**DOCUMENT 00 90 00
ADDENDUM**

ADDENDUM NO. [1] Date: February 17, 2020

**RE: WESTERN TECHNICAL COLLEGE
 APPRENTICESHIP CENTER REMODEL
 2860 21ST PLACE SOUTH
 LA CROSSE, WISCONSIN 54601
 HSR PROJECT NO. 19021**

This Addendum consists of [2] page, [1] specification sections and [9] 30 x 42 drawings.

1 PLUMBING ENLARGED UNDERFLOOR PLAN
1/4" = 1'-0"

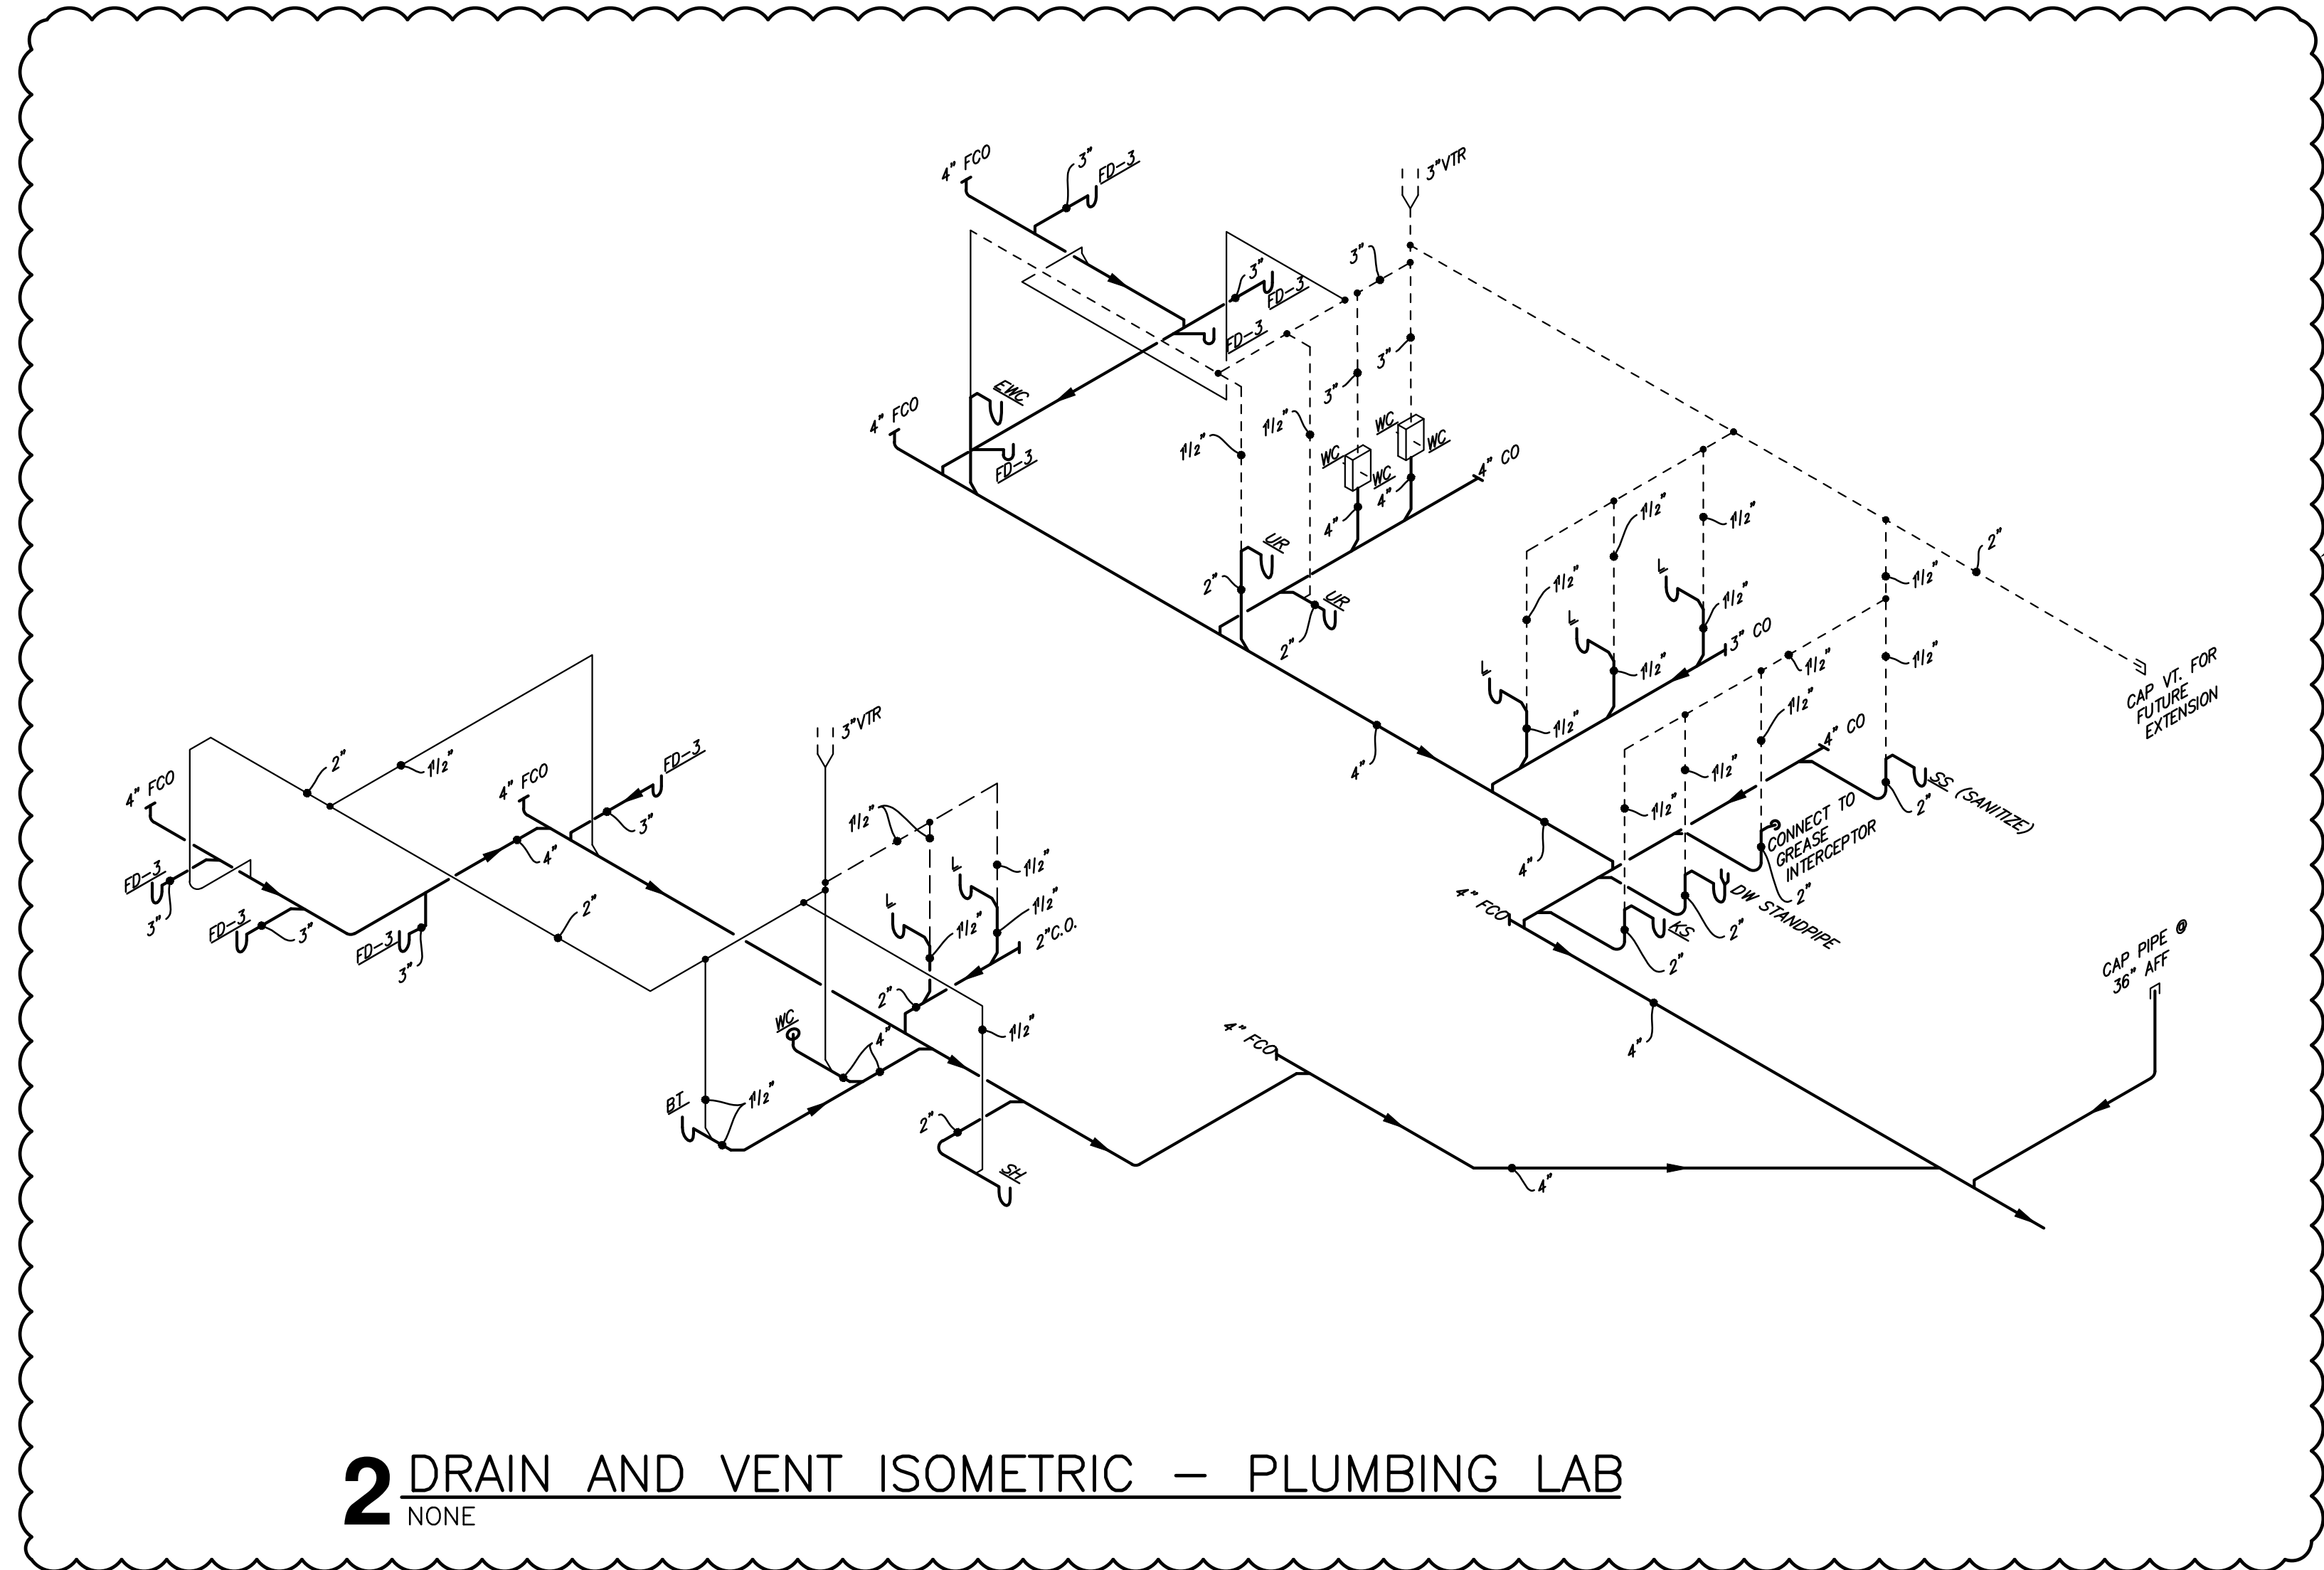
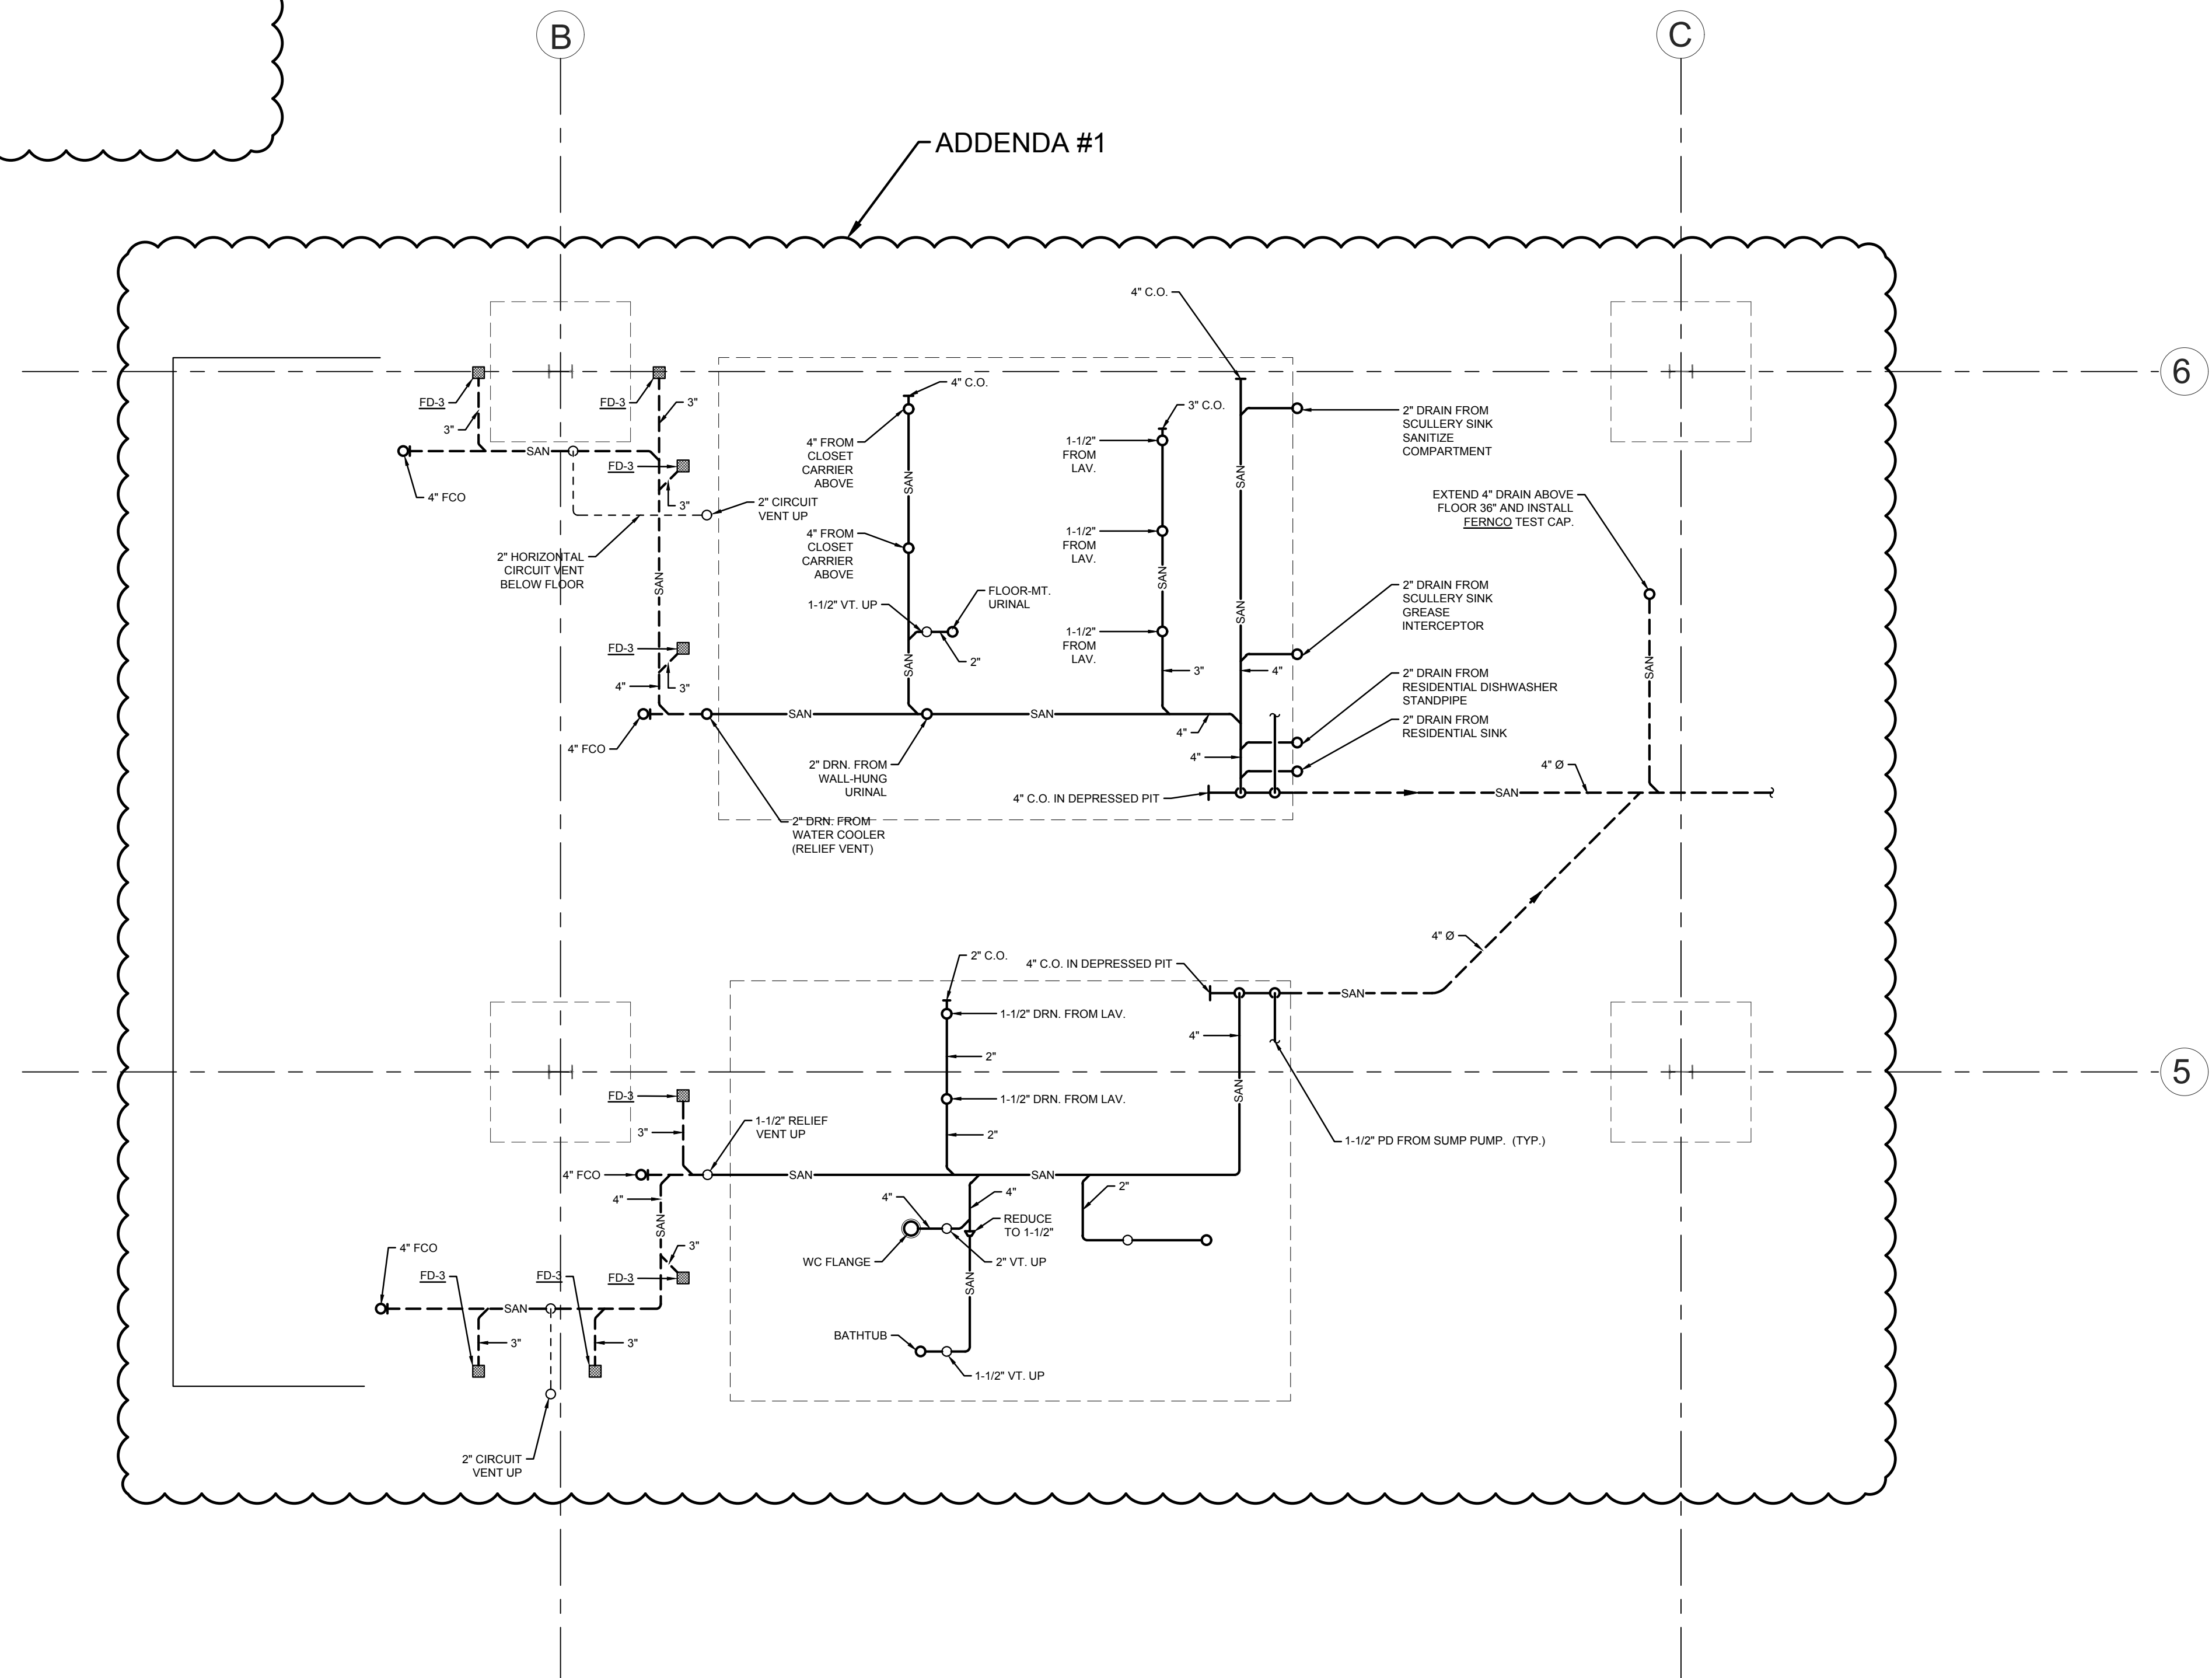
- a. Revisions clouded on Drawing.
10. Sheet P200 PLUMBING ENLARGED UNDERFLOOR PLAN 30 x 42 attached hereto.
 - a. Revisions clouded on Drawing.
11. Sheet P201 PLUMBING ENLARGED FIRST FLOOR PLAN 30 x 42 attached hereto.
